**CENTRAL VALLEY REGIONAL WATER QUALITY CONTROL BOARD
27 FEBRUARY 2026 BOARD MEETING**

Response to Comments
for
City of Woodland, Water Pollution Control Facility
Tentative Waste Discharge Requirements

Figure B-2. Pond System Layout

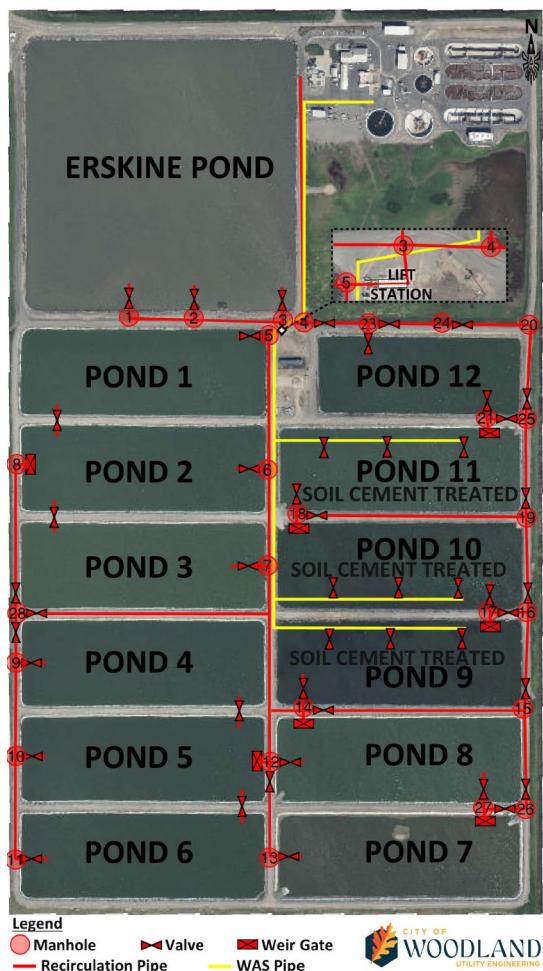
9. Attachment B - Figure B-2, Pond System Layout.

The Discharger requests that Figure B-2 in Attachment B be updated with the updated Pond System Layout the Discharger provided that shows waste activated sludge (WAS) only being distributed to Ponds 9, 10, and 11. The Discharger also notes that the page numbering on this page (B-1) should also be changed to Page B-2.

Response: Staff concur. The updated Pond System Layout provided by the Discharger was included in the proposed Order. The page numbers in Attachment B were corrected and are not shown in this Response. Staff also included an additional Pond System Schematic (Figure C-2 from Order R5-2020-0015) to show the operations of the Ponds. The updated Figure B-2 is shown below. The updated Attachment C – Flow Schematics showing an updated Figure C-1 (Per Ms. Kipps Comments 13) and the Pond System Flow Schematic are shown below.

Figure C-1. Flow Schematic

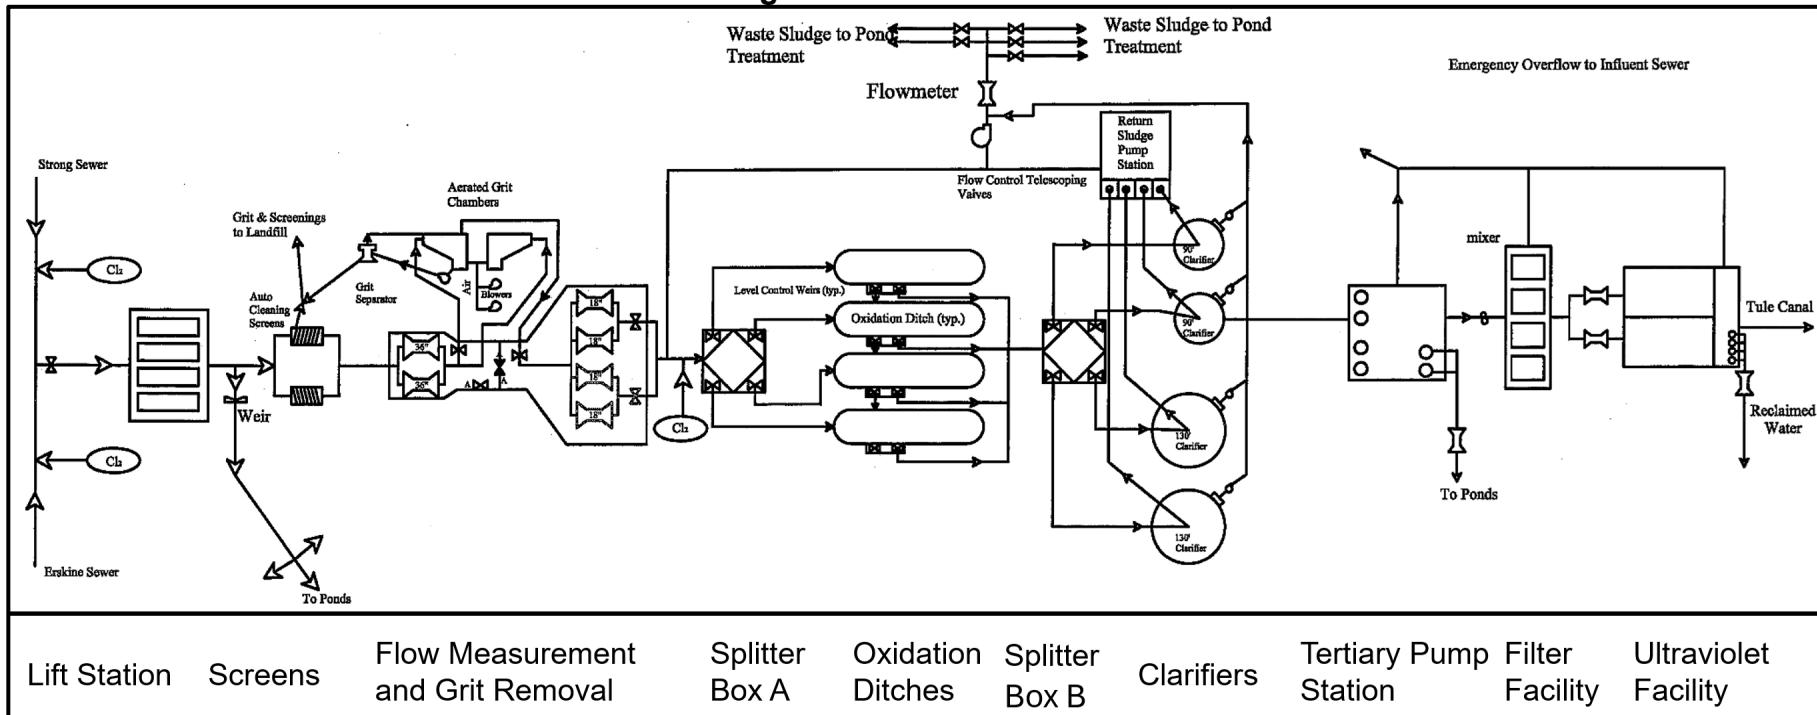
Response: Staff concur. The flow shown on the flow schematic (Figure C-1) was not the design flow. The proposed Order permits a discharge flow of 10.4 Million Gallons per Day (MGD). The reference of 5.6 MGD was removed from Figure C-1. The names of the processes were also added to Figure C-1. The updated Figure C-1 is shown in the response to Discharger Comment 9.

Figure 1. Quantile box plot of WPCF pond nitrate samples (July 2020–June 2024).

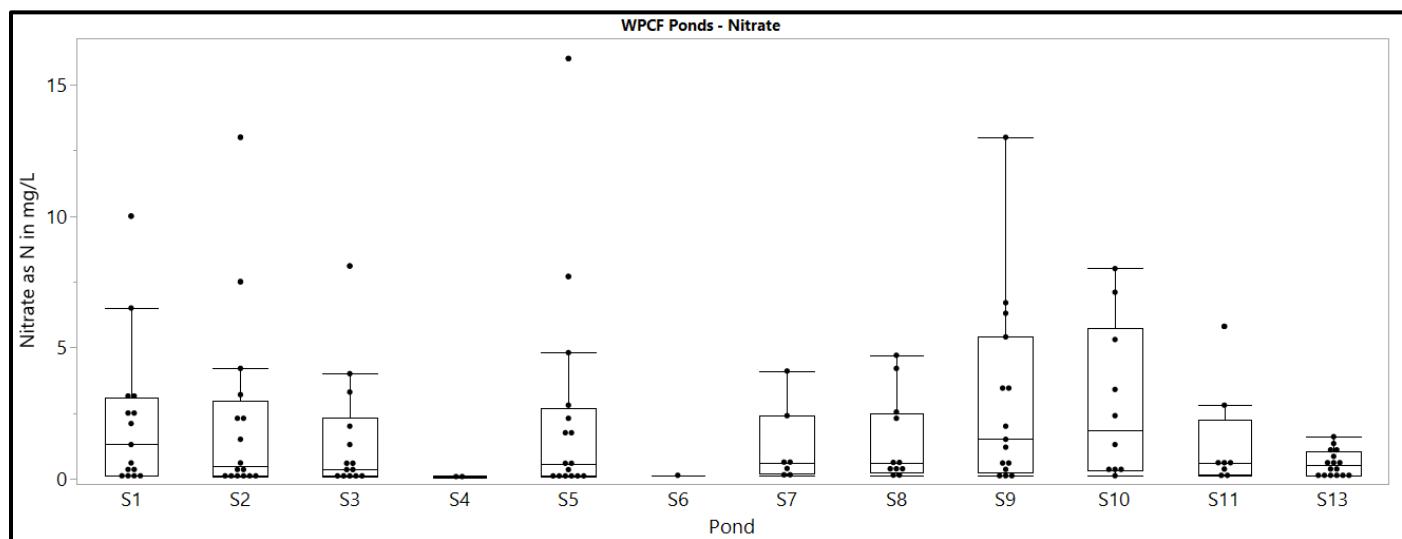
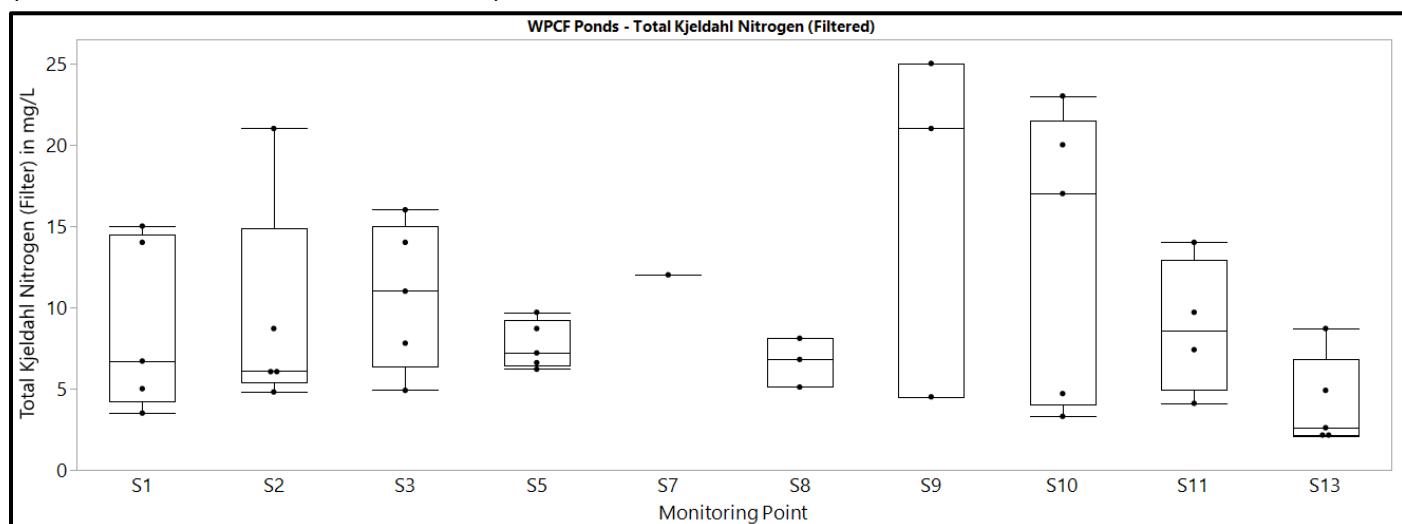
The Discharger collected quarterly nitrate samples from WPCF ponds during the current WDRs term and voluntarily collected quarterly Total Kjeldahl Nitrogen (TKN) pond samples during in December 2024–November 2025 (Figure 1 and Figure 2). The TKN samples were filtered with 1.5-micron TSS filters to remove large particles and algae to better represent the TKN fraction that could leach into groundwater from overlying surface water.

Nitrate in Ponds 1–8, 11, and 13 were similar for the 2020–2024 period, while concentrations in Ponds 9 and 10 were somewhat higher. TKN levels show the same trends as nitrate. Ponds 1–8, 11, and 13 had similar TKN concentrations, while TKN levels in Ponds 9 and 10 were somewhat higher. Pond 12 was not monitored due to low water levels.

Water is continuously circulated through the WPCF ponds and the seepage rates are relatively low—0.18 in/d for Pond 8 (unlined ponds) and 0.07 in/d for Pond 11 (lined ponds) at pond water levels of 4–5 feet. Hence, underlying groundwater is not immediately affected by changing nitrate and TKN levels in the ponds or from pond to pond. The constituents are processed in the ponds, which helps protect groundwater. Accordingly, groundwater TKN and nitrate levels in wells underlying the WPCF (MW-2, MW-6, and MW-11) are low (Figure 3 and Figure 4)—nitrate levels are near non-detect and TKN levels average 0.5 mg/L or less. This is substantially lower than in the overlying ponds (Figure 1 and Figure 2) over the same time period.

Response: Staff concur. Monitoring Location descriptions for ALG-001 and ALG-002 were updated and Monitoring Location SSP-001 was added per the Discharger's comments. Pond monitoring at Table E-6 was reduced to quarterly. The revised Table E-1 is shown in the Response to Discharger Comment 10. The revised MRP section VI.B is shown below:
